Modification Recommended Service Note

J7201B Attenuation Control Unit, DC to 18 GHz, 0 to 121 dB, 1-dB Steps

Serial Numbers: MY59400001 to MY61410177

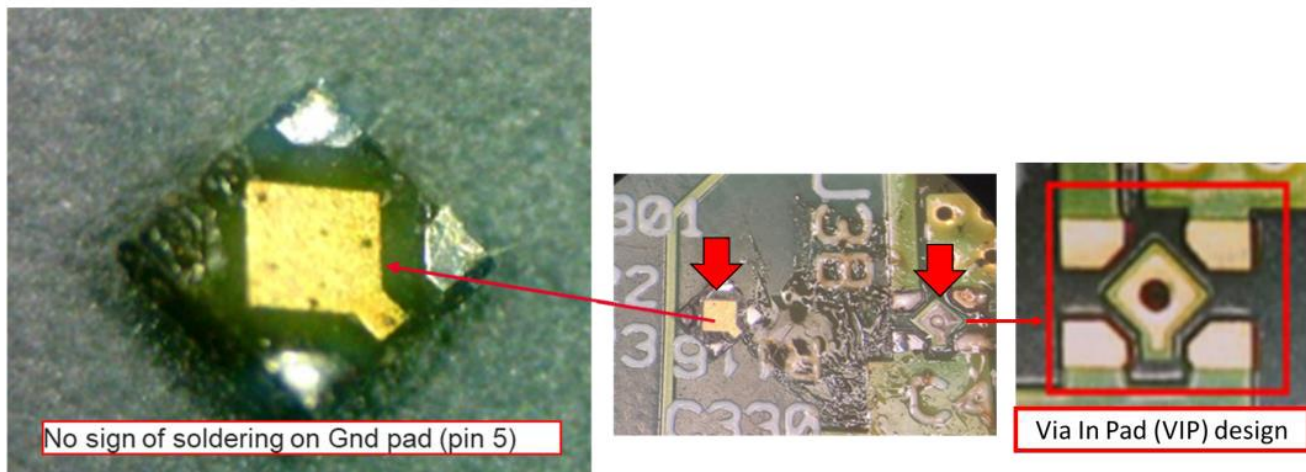
The instrument is unable to boot up and is stuck on the boot-up screen as follows. It is not functioning.

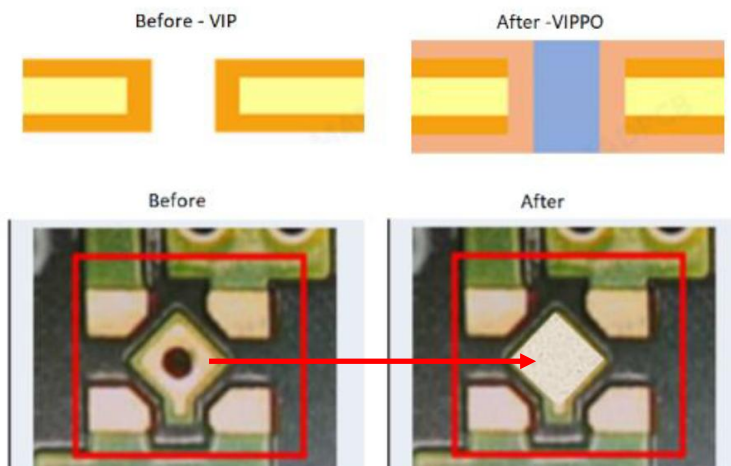
Failure analysis had indicated defective on P0600-63004 board where insufficient solder was observed at 2 locations. The insufficient solder was due to Via in Pad (VIP) where the melted solder had flown to the secondary side of the PCB.

The improvements were made from Via in Pad (VIP) to Via in Pad Plated Over (VIPPO) as per below.

The improved PPMC board have Serial number P06006300423241300007 onwards.

Replace PPMC board P0600-63004 with PPMC board serial number P06006300423241300007 onwards where 13 is the work week and 24 is the year.
